THE MARYLAND-NATIONAL CAPITAL PARK AND PLANNING COMMISSION
8787 Georgia Avenue • Silver Spring, Maryland 20910-3760

M E M O R A N D U M

SUBJECT: Site Plan Review #8-90060 (Revision)
CLOVERLEAF CENTER, PHASE I
I-3 Zone
403,657 square feet of office
SW quadrant of Future Father Hurley Blvd. and Future Century Blvd.
Germantown Planning Area

**A. EXISTING CONDITION
CRYSTAL ROCK DRIVE**

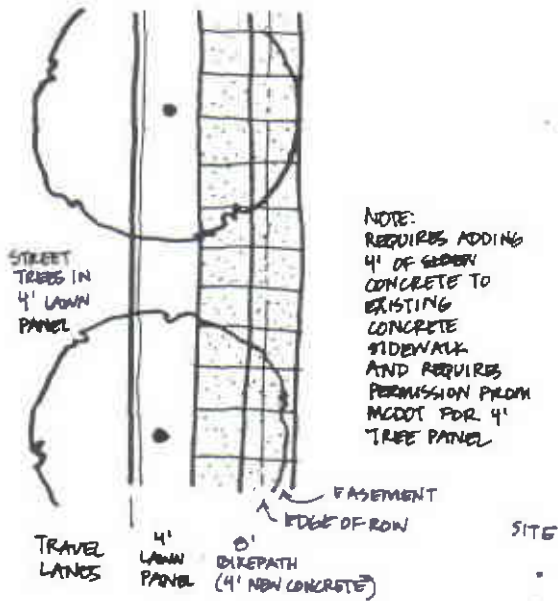
Crystal Rock Drive, a major highway, was built according to an old standard that did not allow for street trees or bikeways in a right-of-way of 120 feet. Staff and MCDOT are now working on amendments to the Road Code to address this problem. The existing four-foot wide sidewalks are four feet from the curb. No street trees have been planted in this portion of Crystal Rock Drive (see sketch A).

Staff recommends provision of street trees between the curb and sidewalk along this section of Crystal Rock. If DOT allows them within the existing four-foot strip, they are to be installed with the construction of the proposal. If DOT requires the trees to be placed in the standard six-foot strip, this will require demolition of the existing sidewalk. In this case staff recommends that the applicant secure funds with DOT for future installation of the street trees at the time of construction of the bikeway.

B. BIKE PATH WITH STREET TREES IN 4' LAWN PANEL CRYSTAL ROCK DRIVE

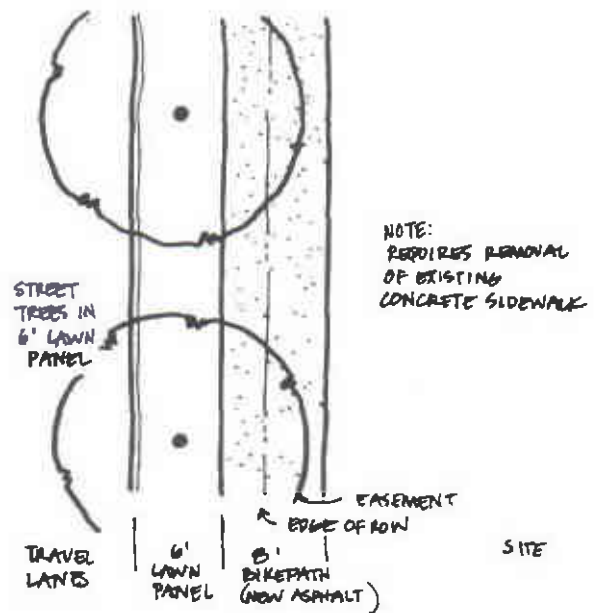
If MCDOT would allow street trees to be planted in the four-foot lawn panel, provision of an eight-foot bikepath would simply require adding a four-foot strip of concrete next to the existing four-foot sidewalk (see sketch B). If MCDOT does not allow this exception to its standard six-foot lawn panel, then the bikepath will require removal of the existing four-foot sidewalk and construction of a new eight-foot asphalt bikepath, six feet from the curb (see sketch c).

7. Applicant to provide a six-foot wide easement along their west property line to accommodate the future construction by others of bikeway in the configuration described in sketch C of the staff report.
